**ORDINANCE 16-24**

**TO AMEND THE ZONING MAPS FROM RESIDENTIAL SINGLE FAMILY (RS) AND RESIDENTIAL HIGH-DENSITY MULTIFAMILY (RH) TO PLANNED UNIT DEVELOPMENT (PUD) AS WELL AS APPROVE A DISTRICT ORDINANCE AND PRELIMINARY PLAN**

**- Re: 600-630 E. Hillside Drive  
(Dwellings LLC, Petitioner)**

Re: Dwellings LLC; South Park PUD Preliminary Plan Approval  
District Ordinance revisions per Plan Commission request 9-12-2016

title: SITE PLAN

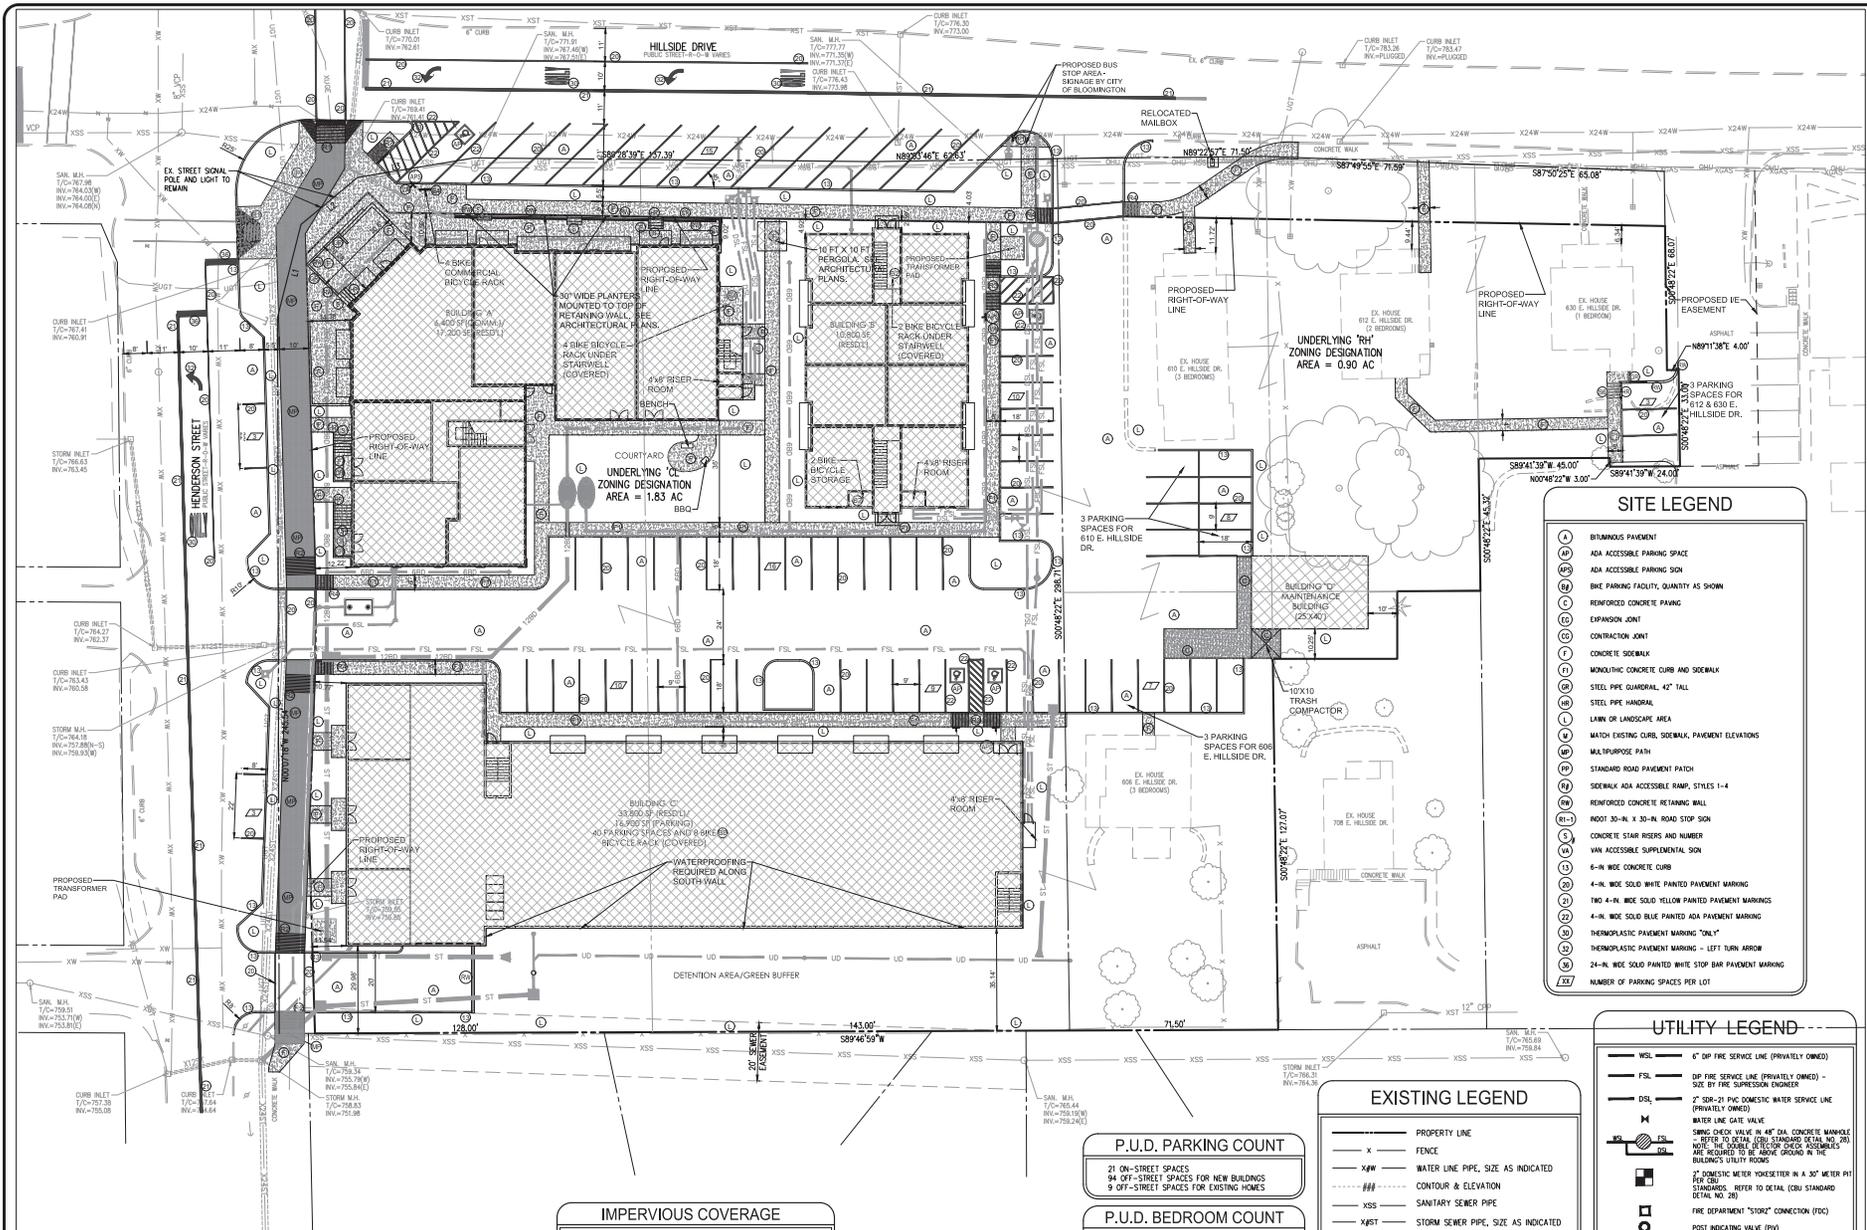
1. The grass in the 5' tree lawn with street trees between the public street and the public sidewalk on Hillside Drive ~~and Henderson Street~~ shall be replaced with concrete and street trees in tree grates. At least 5 street trees shall be planted in grates along Hillside Drive.

This Reasonable Condition (05) is sponsored by Cm Piedmont-Smith. It requires that the 5' wide grass area that is currently planned in the tree-lawn space between street and public sidewalk on Hillside ~~and Henderson~~ be removed and shall be replaced with a concrete surface with tree grates.

The intent of Reasonable Condition (05) is to provide a hard surface, continuous urban sidewalk system for individuals exiting their vehicles on Hillside and Henderson, so that drivers do not have to cross a grassy surface that will be notably difficult to maintain.

1. Provide at least 4 trees along the Henderson Street frontage of the development, plus 4 or more additional bicycle parking spaces along this frontage.

This Reasonable Condition (09) is sponsored by Cm Piedmont-Smith. It requires that in order to complete the streetscape on Henderson Street and to ensure adequate bike parking, street trees in small plots or grates plus additional bike parking be added.

PARK SOUTH - BUILDING A WEST ELEVATION

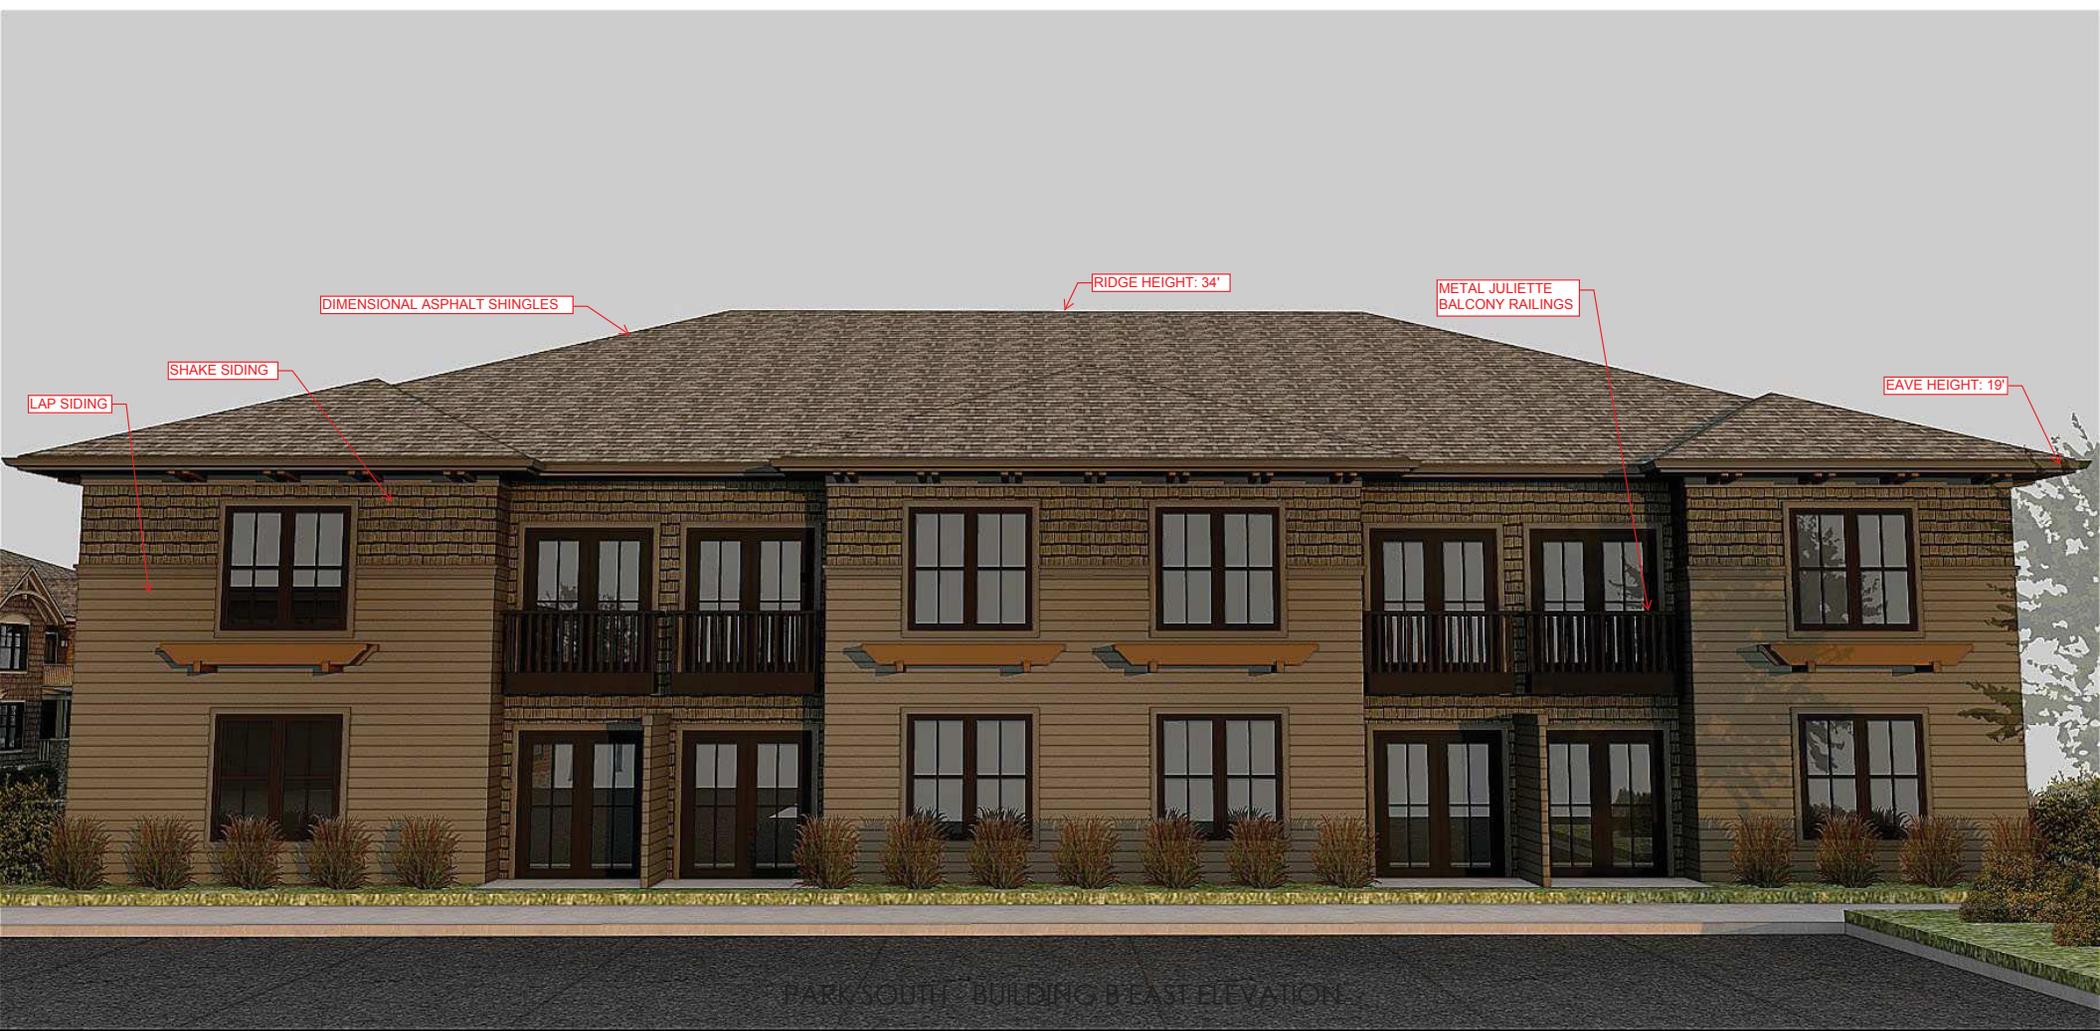
1. The planters separating the sidewalk from the commercial space along the first bay of Building A (westernmost section) on the Hillside Drive frontage shall be replaced by a railing or eliminated altogether.

This Reasonable Condition (04) is sponsored by Cm Piedmont-Smith. It requires that the permanent rectangular planters that are currently placed between the sidewalk and the commercial space in front of the west section of the Hillside Avenue frontage be removed. They shall be replaced by a railing design that does not take up excessive horizontal space or simply removed.
